# Ocean Sweater Ltd.

Islampur, Joydebpur, Gazipur  
(23.980824N, 90.350873E)  
22<sup>nd</sup> March 2015

# Observations

# Punching shear in flat slabs

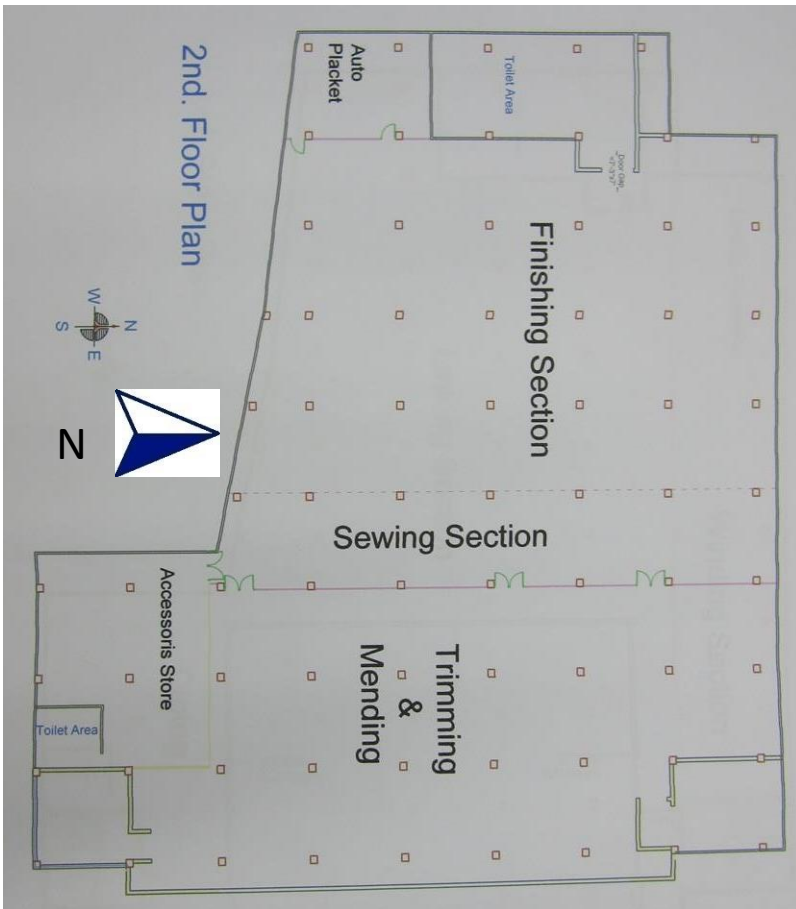
- Hidden beam within slab depth (as per structural drawings) need to be confirmed

Cursory calculations show punching shear stress in flat slabs to be in excess of normal design limits if shear links are not provided.

Item No.	Observation	Recommended Action Plan	Recommended Timeline
1	Punching shear in flat slabs	Ascertain the presence of shear links in the slabs	6-weeks
2	Punching shear in flat slabs	Carry out any necessary strengthening or remedial measures to flat slabs arising from review.	6-months
3	Highly-stressed perimeter columns	Building Engineer to review design, loads and column stresses in the edge columns attracting loads from cantilevers and toilets.	6-weeks
4	Highly-stressed perimeter columns	Verify in-situ concrete stresses by 100mm dia. cores from min. 4 no. columns at ground floor level.	6-weeks
5	Highly-stressed perimeter columns	Produce and actively manage a loading plan for all floor plates within the Production Building, giving consideration to floor capacity and column capacity.	6-months
6	Heavy loading on 4th floor slab (current roof)	Building Engineer to check and verify the design capacity of the structural elements supporting the water tanks.	6-weeks

# Highly-stressed perimeter columns

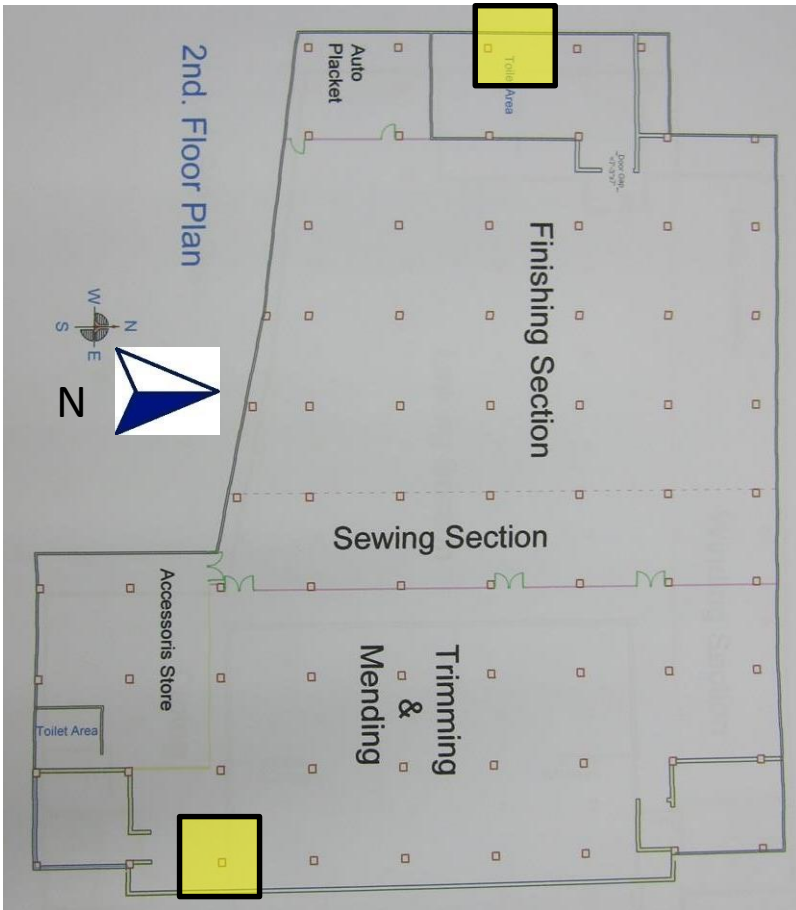
Cursory calculations show stress levels in excess of normal design limits for some perimeter columns.

# Heavy loading on 4th floor slab (current roof)

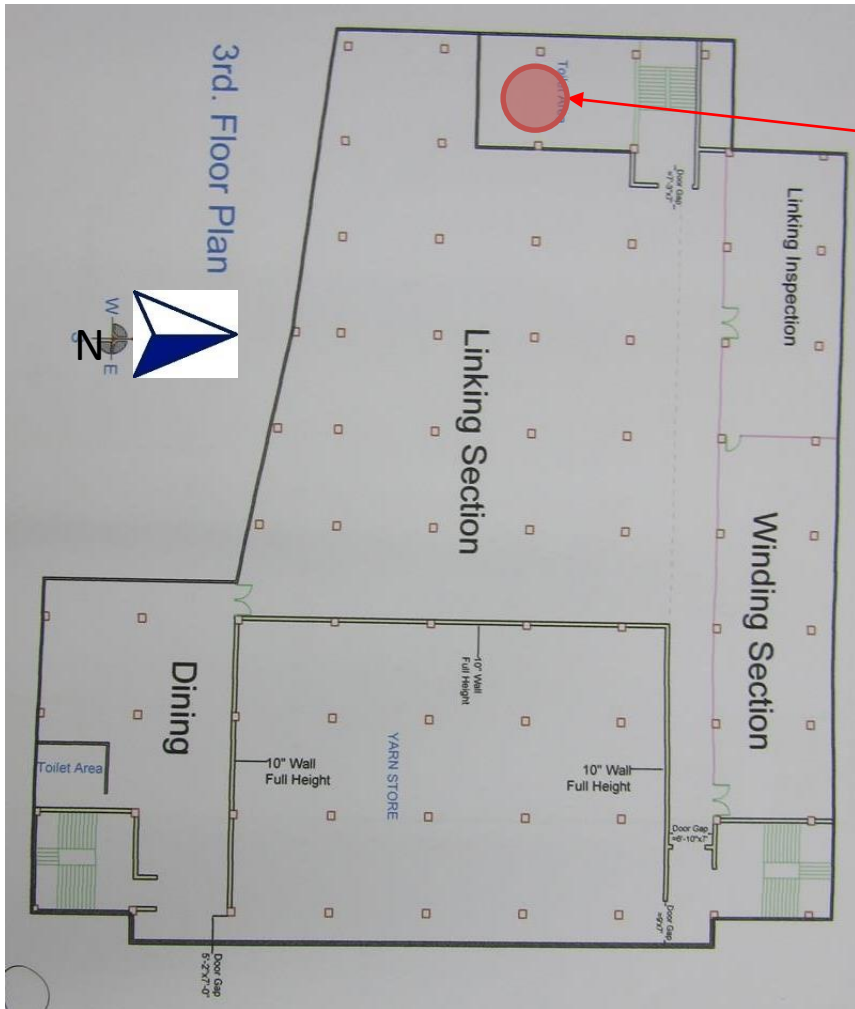
- 10,000 litre Gazi water tank

Heavy loading due to water tank on 4<sup>th</sup> floor/roof.

7	Heavy loading on 4th floor slab (current roof)	The location of the future water tanks to be confirmed.	6-weeks
8	Heavy loading on 4th floor slab (current roof)	If necessary, Building Engineer to take appropriate action by reducing or removing water tanks loads where required, and/or spread the load of the roof water tanks over a bigger and more appropriate area.	6-months

# Discrepancies between permit drawings, structural “as-built” drawings and observed structure

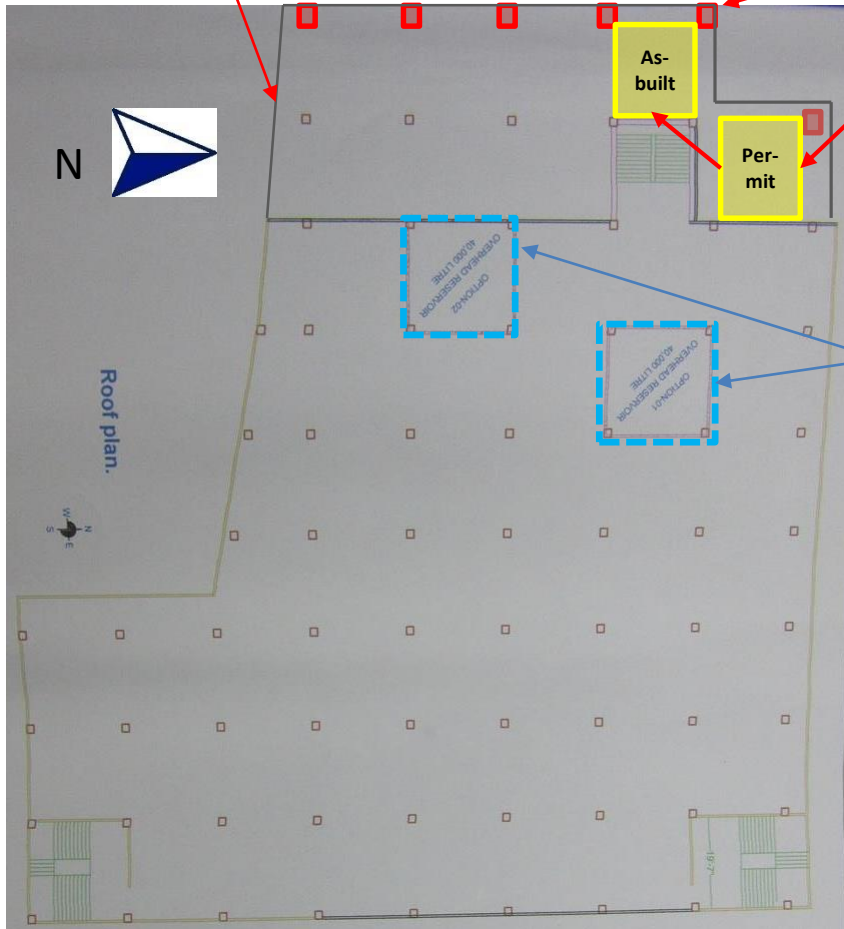
As-built perimeter

- Missing existing column line on drawing of 4<sup>th</sup> floor (current roof)
- Existing staircore moved south-west compared to permit drawings
- Cantilever spans appear to be larger than in structural drawings (no dimensions given)
- Position of future RC water tanks is unclear (water tank shown on as-built drawings above 5<sup>th</sup> floor slab). Future position of water tanks needs to be confirmed

Item No.	Observation	Recommended Action Plan	Recommended Timeline
9	Discrepancies between permit drawings, structural “as-built” drawings and observed structure	Building Engineer to survey the as-constructed building.	6-weeks
10	Discrepancies between permit drawings, structural “as-built” drawings and observed structure	Building engineer to produce accurate and complete as-built documentation showing as-built floor layouts, grids, column and slab dimensions.	6-months
11	Ground floor columns in parking/delivery area vulnerable to vehicle impact	Building Engineer to review and check the capacity of the columns in the parking/delivery area to resist possible vehicle impact.	6-weeks
12	Ground floor columns in parking/delivery area vulnerable to vehicle impact	Building Engineer to assign the required measures to ensure the columns are protected from vehicle impact following review, either by strengthening the columns or by cordoning them off to prevent impact.	6-months

Column layout for 4<sup>th</sup> floor/roof.

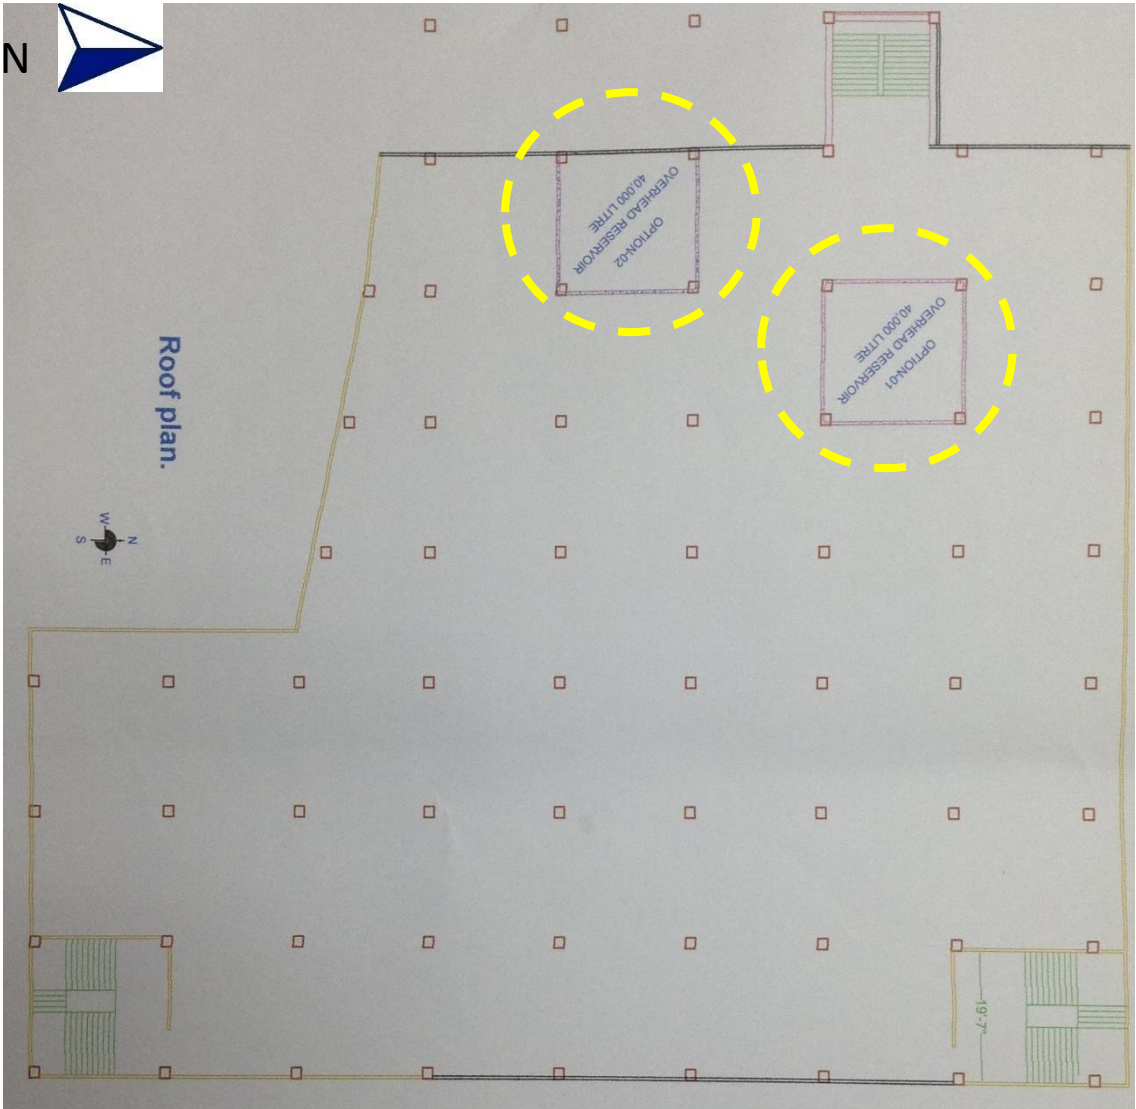
“As-built” drawings show two water tanks which are not yet constructed

# Ground floor columns in parking/delivery area vulnerable to vehicle impact

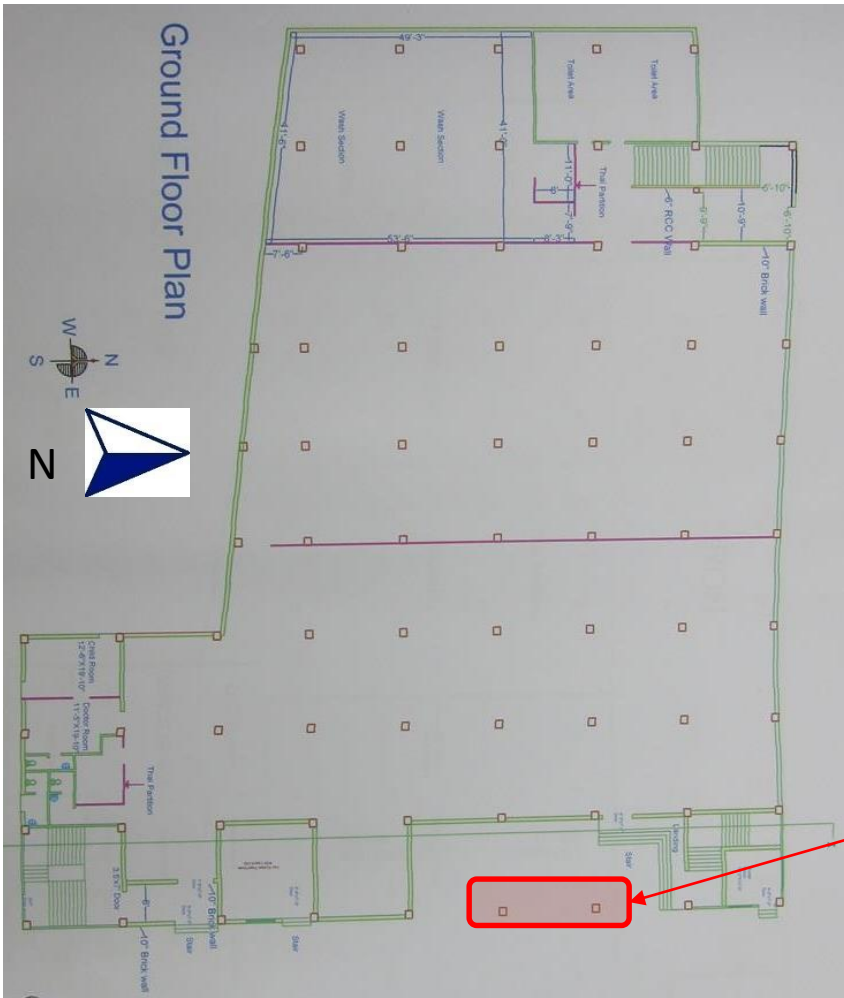
Possible vehicle impact to Ground floor columns in parking/delivery area

# Insufficient cover on manhole in evacuation route

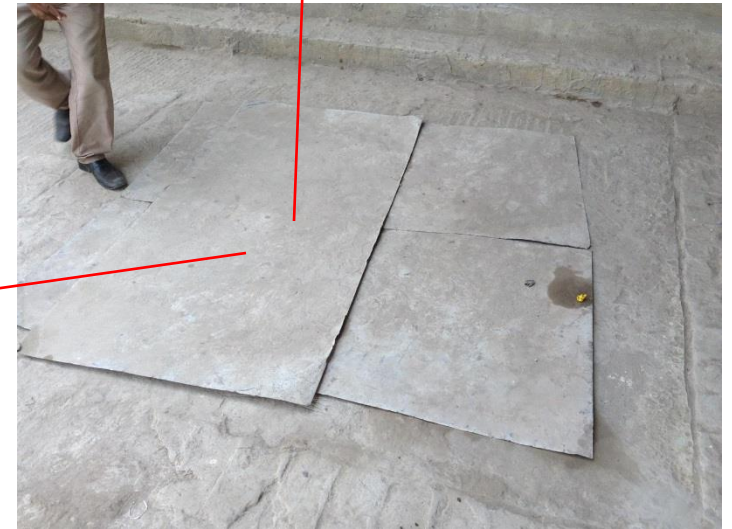
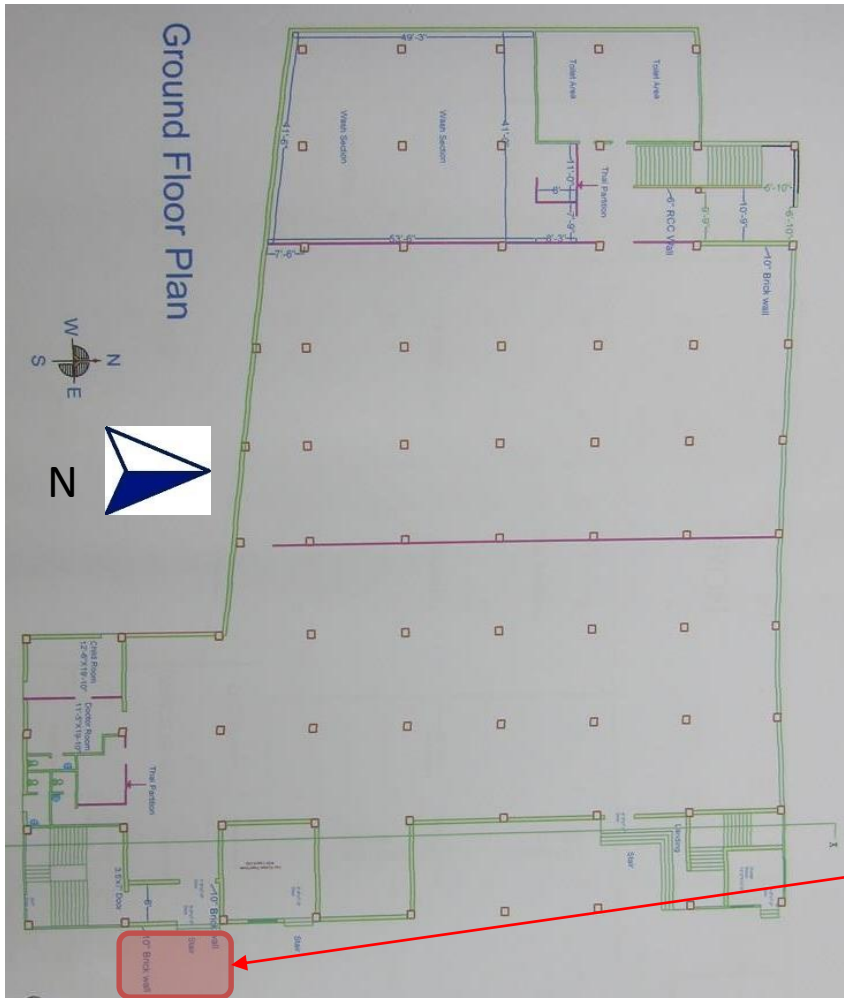
Insufficient cover on manhole in evacuation route. Falling hazard

13	Insufficient cover on manhole in evacuation route	Cordon off area around manhole.	6-weeks
14	Insufficient cover on manhole in evacuation route	Provide proper covers to the manhole to safely transmit vertical loads to the manhole walls.	6-weeks
15	Lateral stability system is not apparent	Building Engineer to investigate the lateral stability of the building, ensuring compliance with Code requirements.	6-months
16	Lateral stability system is not apparent	Implement any structural alterations arising from investigation.	6-months

**Lateral stability system is not apparent**

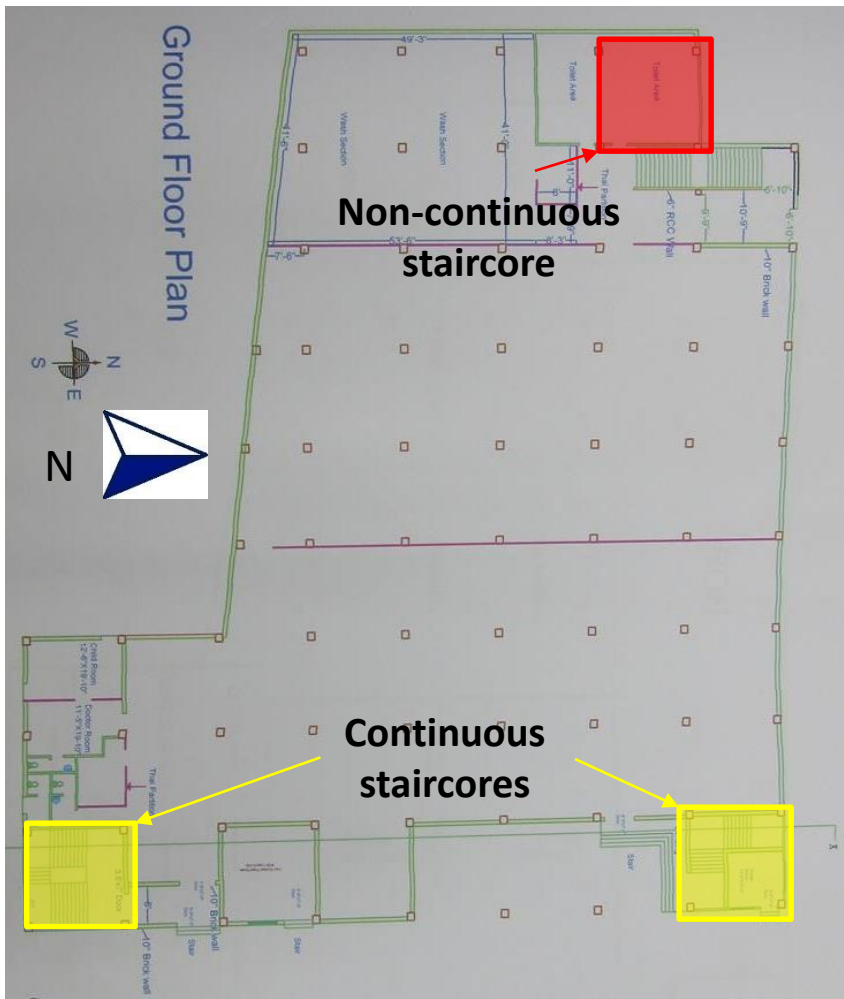
**Lateral stability concerns:**

- Flat slabs on all floors
- 3 staircores, but only 2 of them continue down to ground floor

Lateral stability system is not apparent
